Falcon Tandem with Hydranet Trailing Edge

Falcon Tandem Keel Pocket Modification Diagram Applicable to Hydranet Sails

August 9, 2002

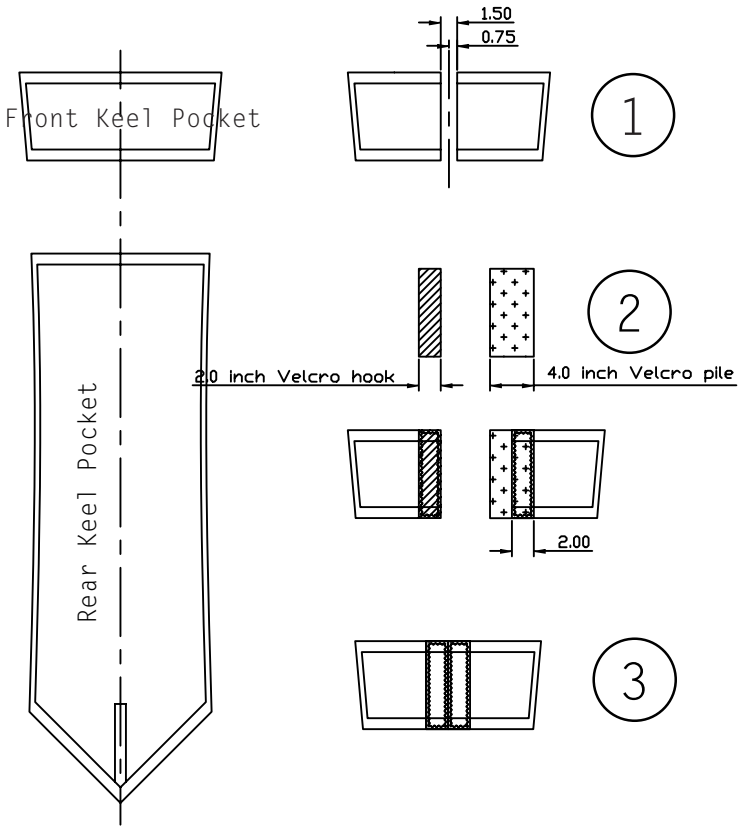
The configuration changes that may be required are to shorten the front keel pocket by ¾" in accordance with the included instructions, and to increase the batten reflex on the #6 and #7 battens to match the indicated lines on the revised batten batten pattern dated September 20, 2002.

Mark the centerline of the front keel pocket (no mod to rear keel pocket). Mark and cut 3/4 inch each side of center, resulting in a 1.5 inch wide gap. Heat seal the fabric edge.

The keel pocket modification kit contains 1 each piece of 2 inch wide hook and 4 inch wide pile type Velcro. Install the 2 inch hook flush with the cut edge of one side of the keel pocket. Install the 4 inch pile overlapping 2.0 inches of the other side of the keel pocket, leaving 2.0 inches of exposed pile. Sew each piece of Velcro to the keel pocket with a perimeter zig-zag stitch of v-92 guage thread.

Mate the cut edges of the keel pocket flush, with 2.0 inches of overlapping Velcro securing the junction.
